**Addendum / Addenda**

No./N°  
2

Project Description / Description de projet		
M-6 Hot Well Piping Replacement		
Solicitation No./ No de sollicitation	Project No./N° de projet	W.O. No./N° d'ordre de travail
14-22025	M6-3562	
Departmental Representative / représentant ministériel		Date
Allan Smith		June 6, 2014
<b>Notice:</b> This addendum shall form part of the tender documents and all conditions shall apply and be read in conjunction with the original plans and specifications.		<b>Nota:</b> Cet addenda fait partie intégrale des dossiers d'appel d'offres; toutes les conditions énoncées doivent être lues et appliquées en conjonction avec les plans et les devis originaux.

**KILWARRNOCK CO.**  
**CONDENSATE RECEIVER**  
**NRC**  
**BASEMENT CONDENSATE RECEIVER**  
**12/766-001**  
**4**

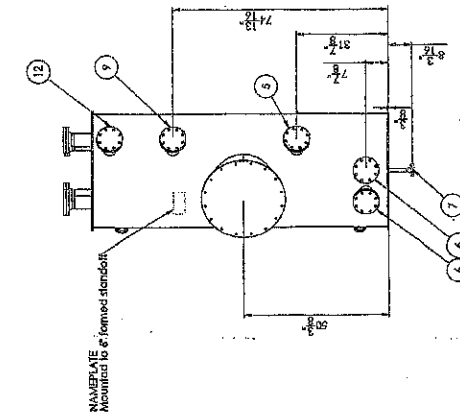
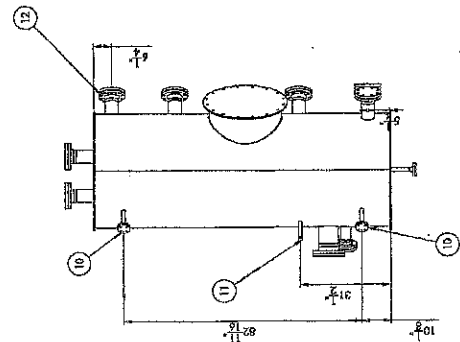
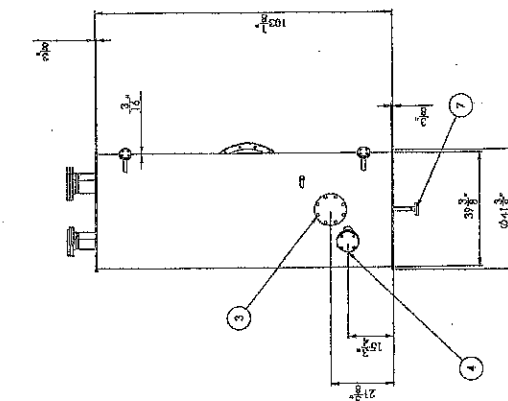
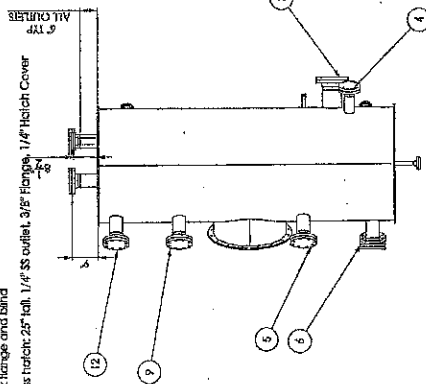
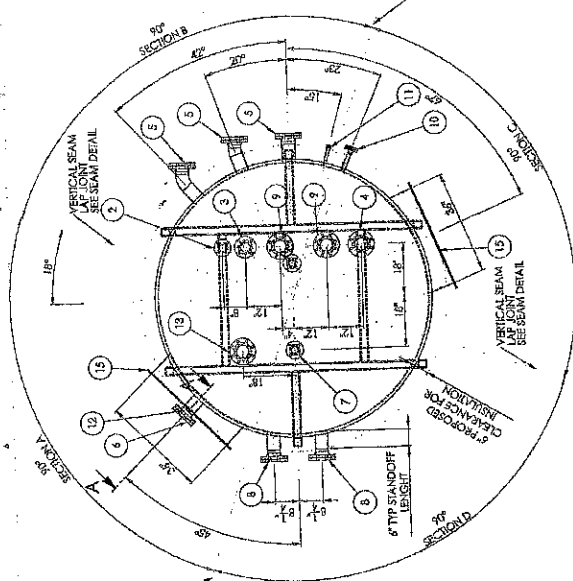
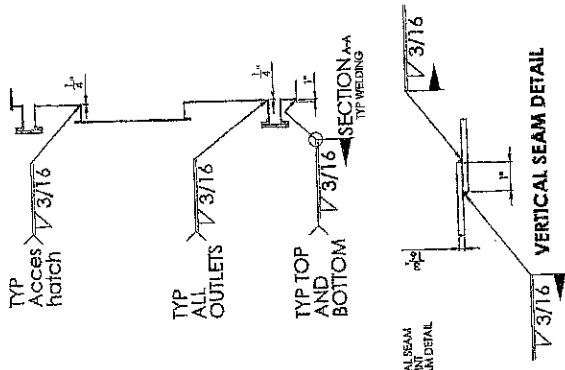
- 1) Can NRC provide drawings for the new Reciever and Hot Well Tanks?  
See attached AS BUILT DRAWING from Kilmarnock Enterprises.
- 2) Can NRC provide drawings of the Dearator that is being removed?  
See attached drawing from E.S.Fox.
